I refer to your email dated 23 September 2016 requesting comments and recommendations from the Environment Protection Authority (EPA) for the Invincible Coal Mine – Southern Extension Project. The proponent (Shoalhaven Pty Limited, T/A Castlereagh Coal) is seeking to modify the existing consent to permit the extraction of up to 1.2 million tonnes of run-of-mine (ROM) coal annually for up to 8 years.

The EPA has reviewed the Invincible *Southern Extension Project – Environmental Assessment* (EA) and is not in a position to provide its preferred operating conditions at this stage as the review has revealed several major limitations with particular reference to the water components of the project.

ATTACHMENT 1

Figure 6. Groundwater bores in the vicinity of Invincible Mine. Source: AGE 2016.

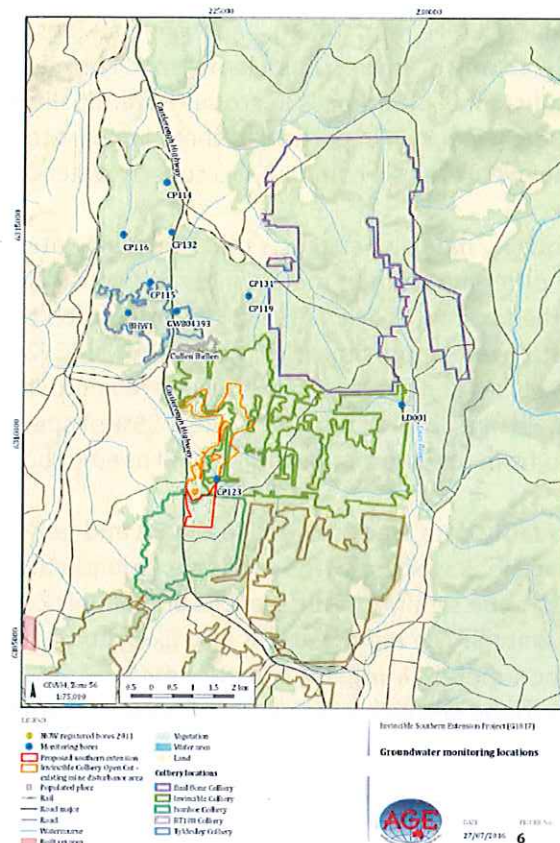
AGE(2016) identified groundwater monitoring bores in the vicinity of the Southern Expansion Area, only one of which (CP123) is within 5km of the proposed mining (see Figure 6). AGE (2016) also noted, however, that CP123 was measuring the Marrangaroo Formation (sandstone / conglomerate) and that it was now '*discontinued*'. This suggests that there are no functional groundwater bores within 5 km of the proposed mining in the Southern Extension Area. This potentially explains why there is such high uncertainty in ground water levels in the old Ivanhoe No. 2 workings and therefore the volume of water that needs to be removed. The current set of bores identified in the EA are not considered to provide an appropriate set of groundwater monitoring sites for understanding the effects of future development of this area.

The lack of fundamental data on ground water levels in the old Ivanhoe No. 2 workings and therefore the actual volume of water that needs to be removed is a major deficiency in the current EA, one which should have been addressed prior to the public exhibition of the EA. Assumptions used to estimate the volume of mine water to be removed do not allow for the sinkholes that occur in the Cullen Ck tributary upstream of the current open pit area or additional inflows from the upstream catchment. There is also no assessment of the effects that mapped regional joint sets in this area may have on groundwater flows.

Figure 7. Principal Components Analysis of Groundwater Data (Physico-chemical - top; ionic composition - middle; and metals - bottom). Data for Newnes Plateau Streams and Clarence Colliery Discharge included for comparison¹⁶. Source: McElroy 1975, AGE 2014, Sedgman 2016, OEH 2015.

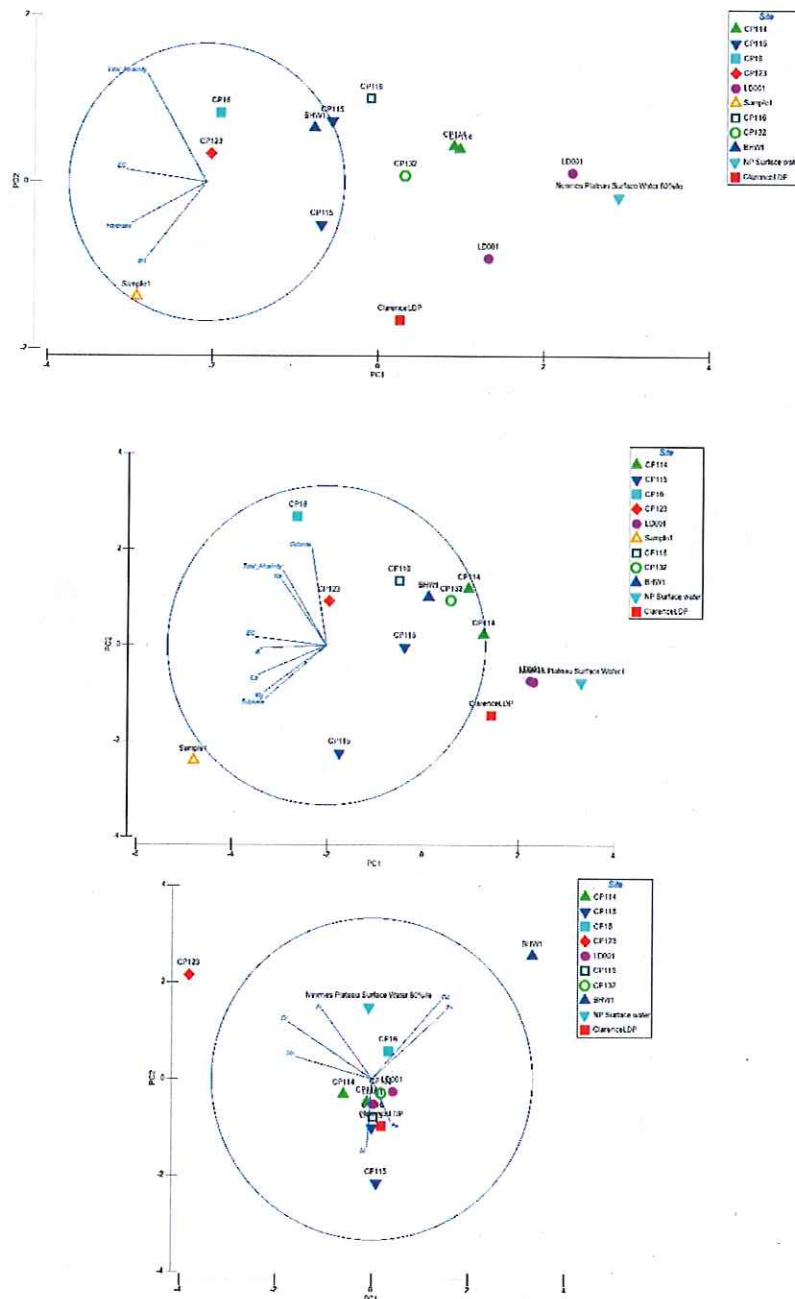
selected dissolved metals (Al, Cd, Cr, Fe, Mn, Ni, Zn), and major salt ions (calcium, sulphate, chloride, magnesium, potassium and sodium) to show site similarities and correlations with each chemical group. The results identify substantial differences in groundwater quality when compared to Newnes Plateau surface waters (Figure 7). In particular, there appears to be significant differences in the ionic composition of mine waters when compared to surface waters.

The available groundwater quality data also suggests that the mine water is potentially high in Nickel and Zinc¹⁴ and, on occasion, other metals/non-metals/inorganic constituents (e.g. chromium and manganese). This supports the findings of AGE (2012, 2014). It is noted that the average Nickel concentrations in groundwater were approximately twice the ANZECC (2000) default guideline level (11 µg/L) to protect 95% of species and average Zinc levels were approximately seventeen times¹⁵ the ANZECC (2000) default guideline level (8 µg/L) to protect 95% of species. This suggests that any groundwater that is pumped from underground workings will need to be treated prior to discharge.

Figure 8. Water Quality in the Main Dam, Environmental Dam, BSW01, BSW02 and other locations. Source: Invinible Annual Environmental Monitoring Reports and EPA/OEH.

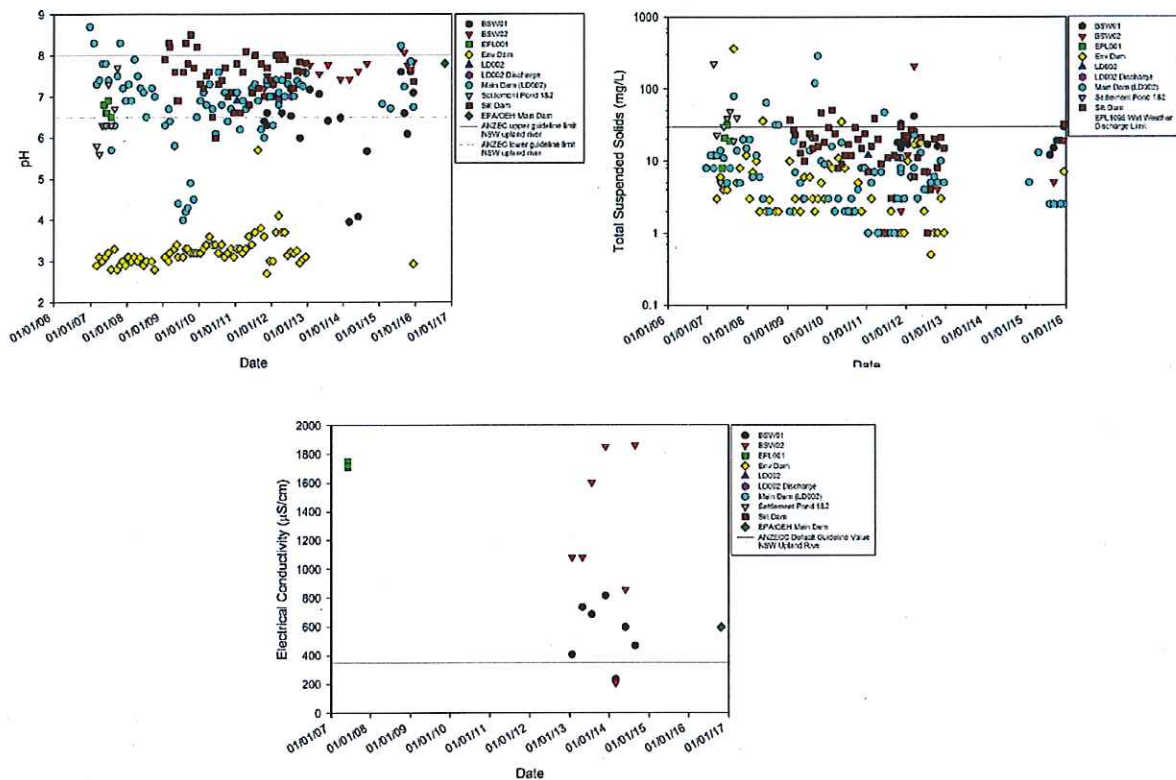
The limited data that is available suggests that the Main Dam (LDPO02) can occasionally have relatively high pH¹⁷ and total suspended solid levels. The Environmental Dam usually has very acidic waters (pH≈3). Conductivity levels at BSW01 and BSW02 are often high (relative to the default ANZECC 2000 guideline level for upland streams of 350 µS/cm).
